1980 CB650 ACCELERATION PERFORMANCE

MTB 1983 8008

AIR CLEANER COVER SET INSTALLATION AND ROUTING

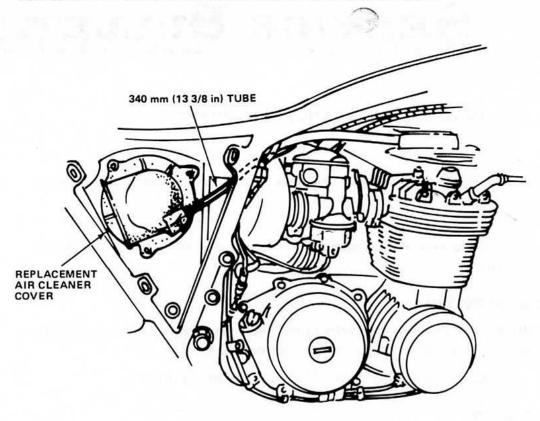
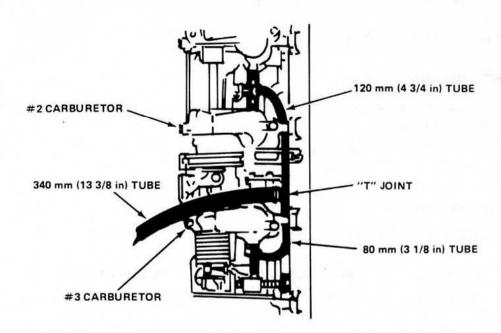
Poor initial response when the throttle is suddenly opened while running at high rpm.

Rich fuel mixture due to excessive pressure differential between each venturi and externally vented float chamber.

If the customer experiences this acceleration performance problem, install air cleaner cover set, P/N 17225-460-670, which replaces the original float chamber vent tubes with tubes that vent the float chambers into the air cleaner case.

Route the new vent tubes as shown on page 2.
